HISTORIC LANDMARK COMMISSION STAFF REPORT

200 Apartments- New Construction
Case PLNHLC2013-00239
and PLNHLC2013-00240
206 North 200 West
July 18, 2013

Applicant:
Matt Musgrave

BUILDING COMPARISONS
NEW 200 APARTMENTS FOR MATT MUSGRAVE
206 NORTH 200 WEST
SALT LAKE CITY, UTAH 84103

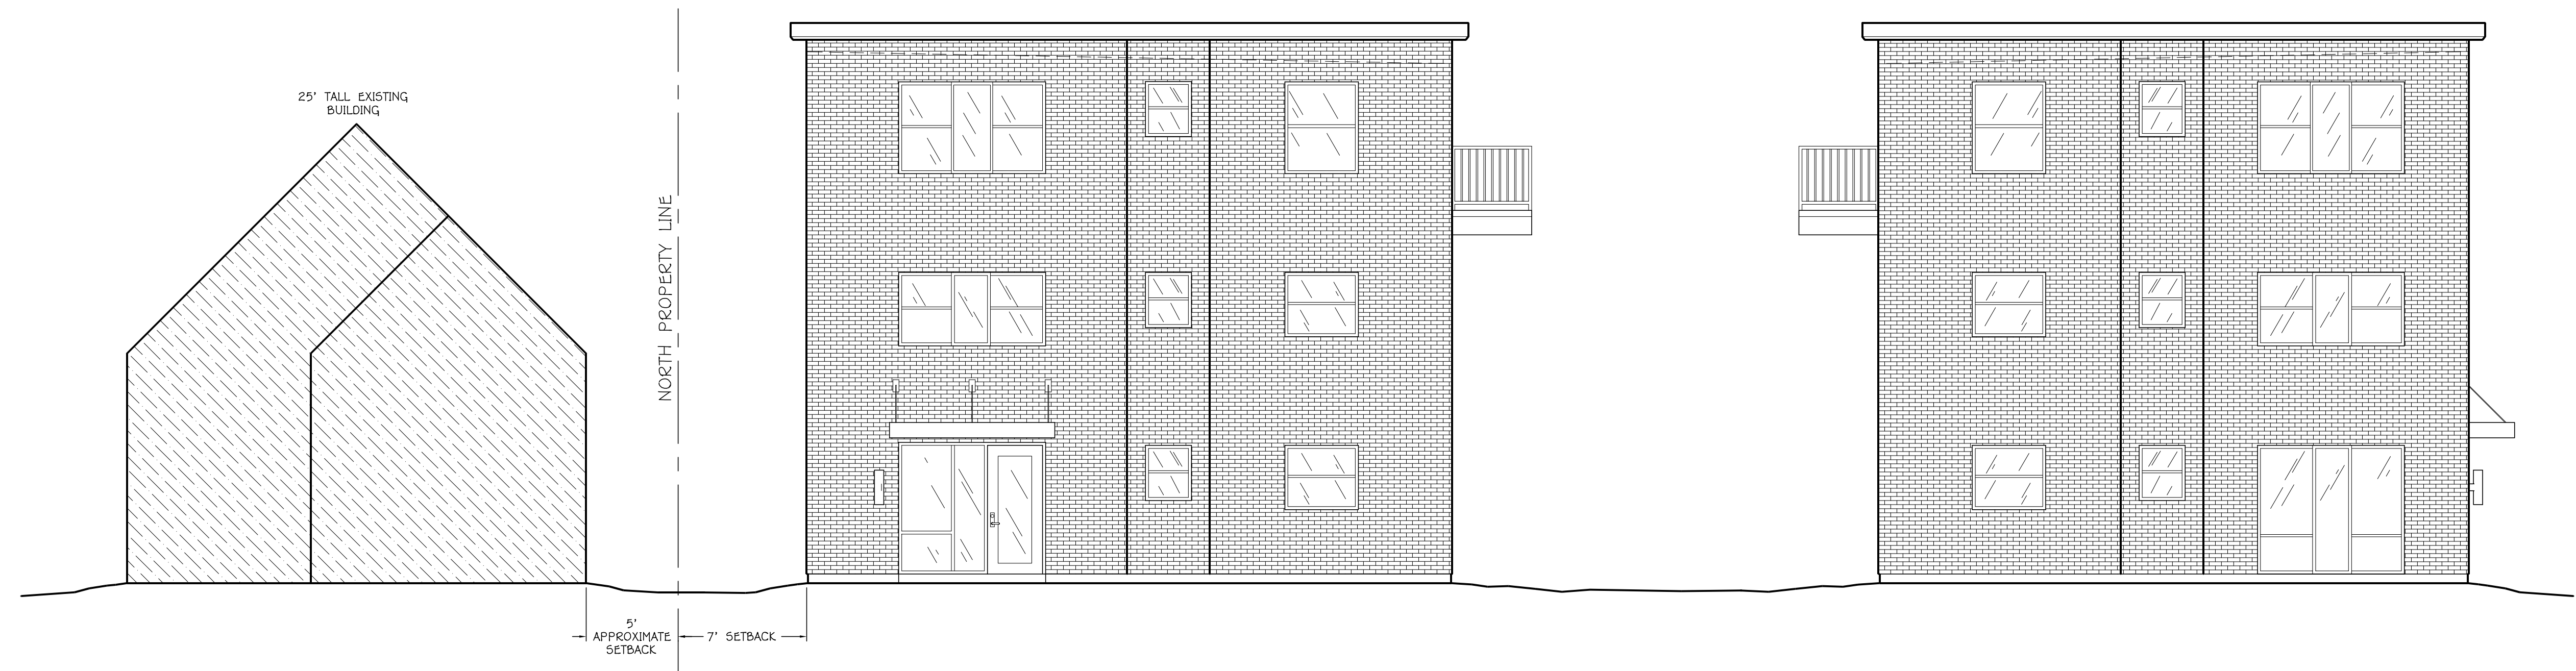
Although the proposed building would be taller than that which is allowed in the CN zone, it will have a similar width and height to the surrounding structures. The proposed structures will be three stories with a height of 30 feet and a width of approximately 80 feet facing 200 North, and 32 feet facing 200 West. The apartment buildings located directly to the east are approximately 35 feet in height, while the apartments located to the west are about 50 feet in height.

The residential building to the north (along 200West) is approximately 25 feet in height and 25 feet in width. The impacts of the new buildings will be mitigated by the fact that the width of the proposed buildings facing 200 West, is similar (32 feet) to the residential buildings. Further, because the height of the surrounding apartment buildings is greater than that which is proposed, the 30 foot building will become a transitional element between the single family and multi family structures.
